June 21, 2019

HANDOUT 8.1-A

Date: June 21, 2019
To: Alison Kearns, Chief, Risk Analysis Branch, FEMA Region IX
CC: Eric Simmons, Ed Curtis, Patrick Clancey, Michael Bishop, FEMA Region IX
From: Nicole Metzger, STARR II
Subject: Santa Clara County BAC Study Appeal Review (MIP Case No. 17-09-0342S)

Figure 1: 1-percent-annual-chance Stillwater Elevation of San Francisco Bay and Bayfront pond (Pond A3N)

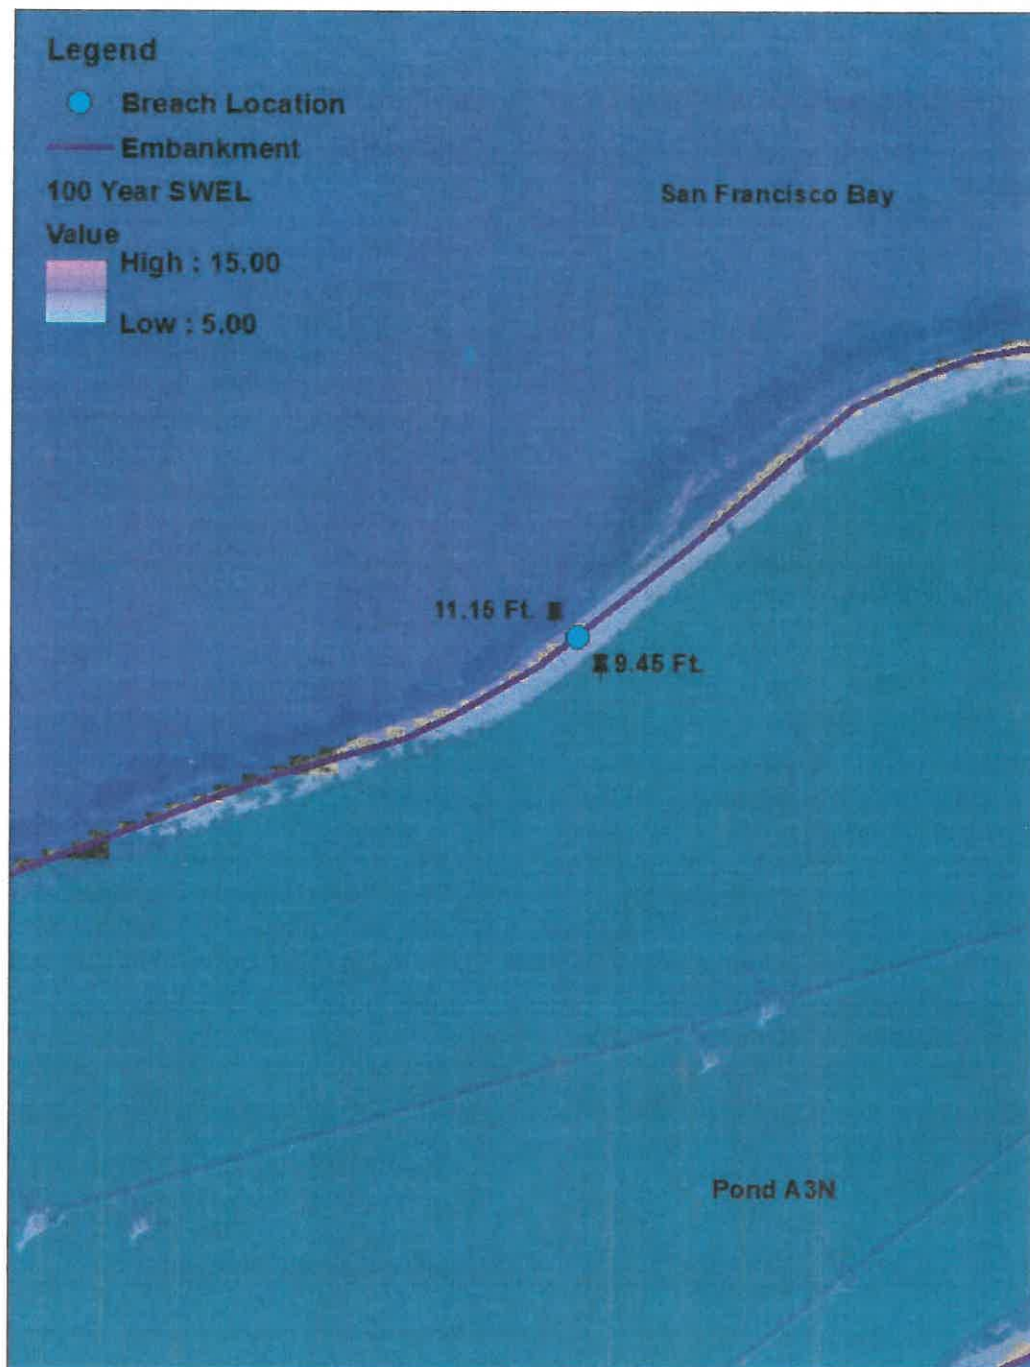
The largest difference in the 1-percent-annual-chance stillwater elevation submitted by Valley Water between the Bay and the first salt pond, as seen in Figure 1, is nearly 2 feet. This difference in the stillwater elevation is evidence that the approach being used by Valley Water is giving the berms credit for flood protection that has not been proven based on available documentation. The use of a wider external berm breach and additional breach locations could reduce this difference and should be explored through sensitivity analysis.

Figure 4: Screen Capture of transect locations: Yellow = FEMA Transect 13; Green = Valley Water Transect 48

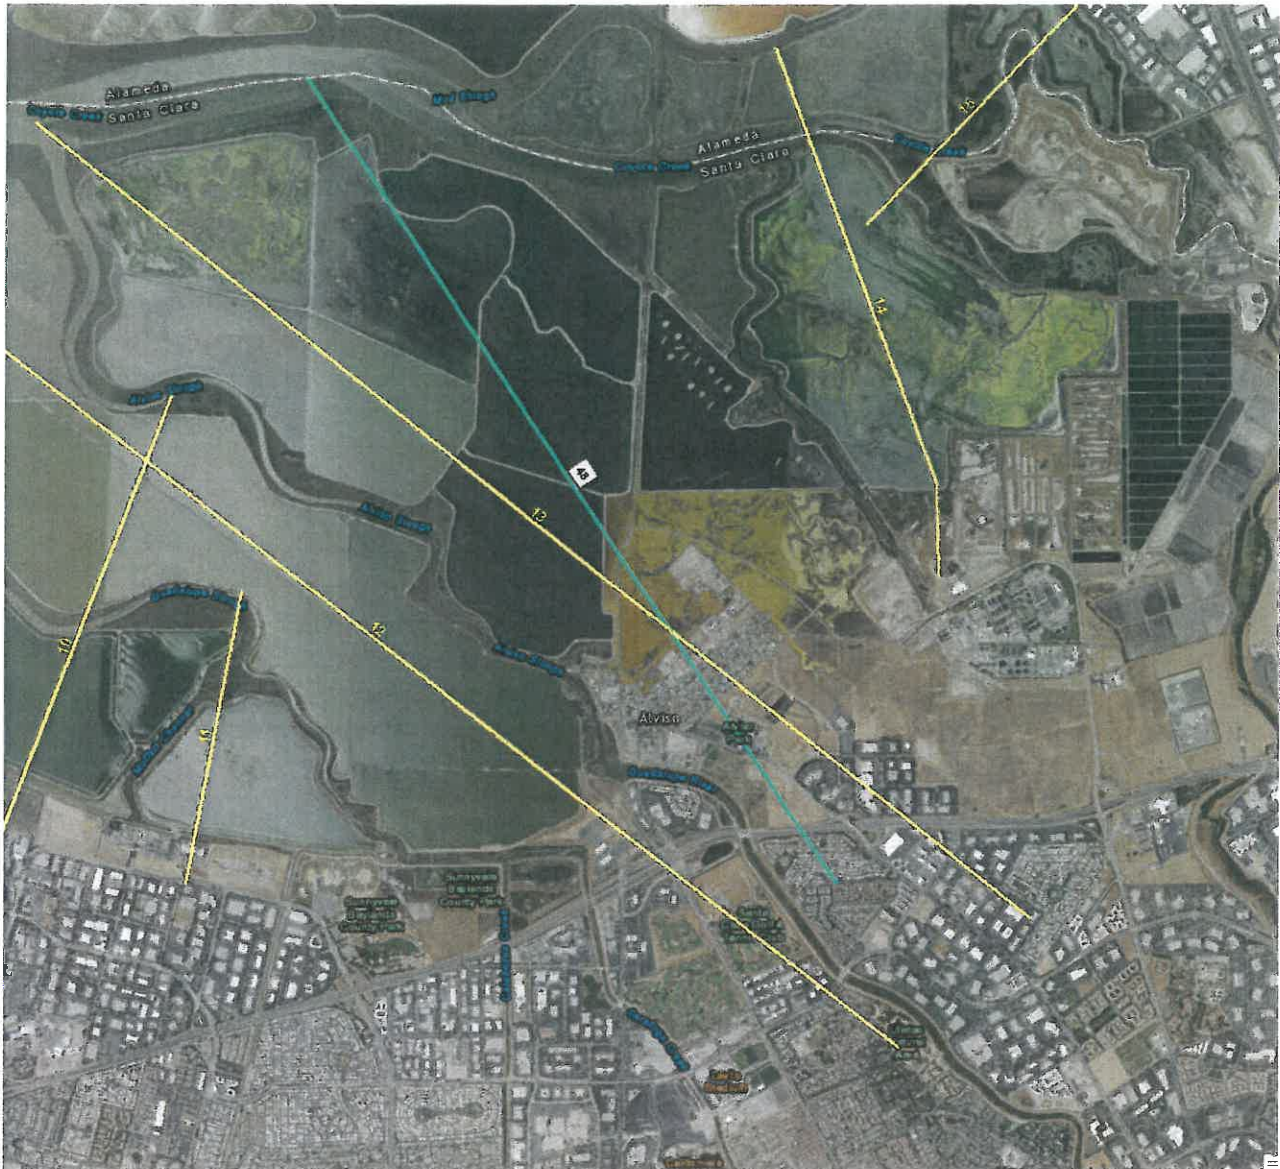
- b. Four transects were roughly co-located between the two studies, offering the chance to directly compare the inputs and results from each. Resultant BFEs at the shoreline at these co-located transects were 0-3 feet lower in the Valley Water study as compared to the FEMA study.
- c. The greatest difference in BFEs between the two studies was observed onshore in a developed area in the vicinity of FEMA Transect 11, where the Valley Water BFE was 5 feet lower than the FEMA BFE. This area is highlighted in turquoise in the Figure 3 below.

- d. A comparison of the Valley Water and FEMA study results suggests that the Valley Water method may be underestimating the 1-percent-annual-chance base flood elevations onshore. An example which is typical across the study area is Valley Water Transect 48, which informs the onshore mapping in the vicinity of FEMA Transect 13 (See Figure 4). Due to differences in transect orientation between the two studies, these transects do not correlate directly, so the WHAFIS results cannot be compared side by side. Instead, the mapping results from both studies were assessed along the Valley Water transect for comparative purposes.
